UNITED STATES PATENT AND TRADEMARK OFFICE

APPLICATION NO.	FILING DATE	FIRST NAMED INVENTOR	ATTORNEY DOCKET NO.	CONFIRMATION NO.
10/601,789	06/24/2003	Norio Kimura	2003-0865	9516

<p align="center">Office Action Summary</p>	<p>Application No.</p> <p>10/601,789</p>	<p>Applicant(s)</p> <p>KIMURA ET AL.</p>	
	<p>Examiner</p> <p>Hadi Shakeri</p>	<p>Art Unit</p> <p>3723</p>

DETAILED ACTION

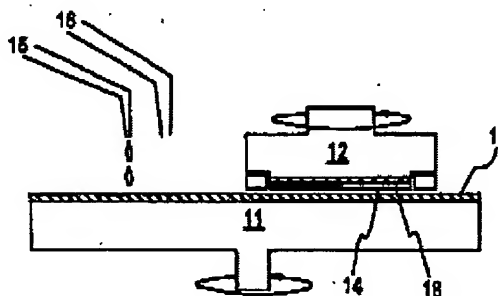
Lenkersdorfer discloses all of the limitations of claims 36, 37, 40 and 43, i.e., a polishing table (300) having a polishing surface (250), a substrate carrier (170) having a lower surface for holding a substrate (125) and bringing the substrate into contact with said polishing surface, a liquid supply nozzle (not shown), and a film thickness

measurement device (310) for determining an end point of the polishing and being positioned at an outer peripheral portion of the table, except for disclosing an attitude control mechanism for keeping the lower surface of the substrate carrier parallel with the polishing surface and a nozzle providing water to the pad.
